APPLICATION NO.	FILING DATE	FIRST NAMED INVENTOR	ATTORNEY DOCKET NO.	CONFIRMATION NO
10/539,689	02/21/2006	Rolf Brocke	85934.000054	4956
23387 7590 01/14/2009 Stephen B. Salai, Esq. Harter Secrest & Emery LLP			EXAMINER	
			REDMAN, JERRY E	
1600 Bausch & Lomb Place Rochester, NY 14604-2711			ART UNIT	PAPER NUMBER
			3634	
			MAIL DATE	DELIVERY MODE
			01/14/2009	PAPER

Application No. Applicant(s) BROCKE, ROLF 10/539,689 Office Action Summary Examiner Art Unit Jerry Redman 3634 -- The MAILING DATE of this communication appears on the cover sheet with the correspondence address --Period for Reply A SHORTENED STATUTORY PERIOD FOR REPLY IS SET TO EXPIRE 3 MONTH(S) OR THIRTY (30) DAYS. WHICHEVER IS LONGER, FROM THE MAILING DATE OF THIS COMMUNICATION. Extensions of time may be available under the provisions of 37 CFR 1.136(a). In no event, however, may a reply be timely filed after SIX (6) MONTHS from the mailing date of this communication. If NO period for reply is specified above, the maximum statutory period will apply and will expire SIX (6) MONTHS from the mailing date of this communication - Failure to reply within the set or extended period for reply will, by statute, cause the a

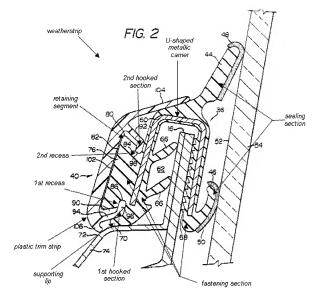
Claims 1, 5, 7-10, and 12-14 are further rejected under 35 U.S.C. 102(b) as being anticipated by U.S. patent to Kaye et al. (6,409,251 B1). Kaye et al. (6,409,251 B1) disclose a weather-strip (see Figure below) comprising a sealing section (44, 46, 48, and 50), a U-shaped fastener section (66, 68, 70, and 76) having a metallic carrier, and a plastic trim strip (40) positively connected to the fastening section (66, 68, 70, and 76). Kaye et al. (6,409,251 B1) further discloses the plastic trim strip (40) comprising a first hooked section (90) extending within a first recess (86) and second hooked section (98) extending within a second recess (84). Kaye et al. (6,409,251 B1) still further discloses a retaining segment (80), a supporting lip (70), and a U-shaped metallic carrier (60).

The applicant's arguments have been considered and are not deemed persuasive. The applicant argues that the "retaining segments" of Kaye et al. (6,409,251 B1) is not pivotal. The Examiner respectively disagrees. Since the retaining segment (shown above) is formed of thermoplastic and further has notches, this allows flexibility to attach the plastic trim strip. Therefore, some pivoting will occur when attaching the plastic trim strip. Still furthermore, the applicant states that it is the plastic trim strip that flexes and not the retaining segment. Again, the applicant respectively disagrees since both elements are flexible and when attaching, both elements will bend, flex and "pivot".
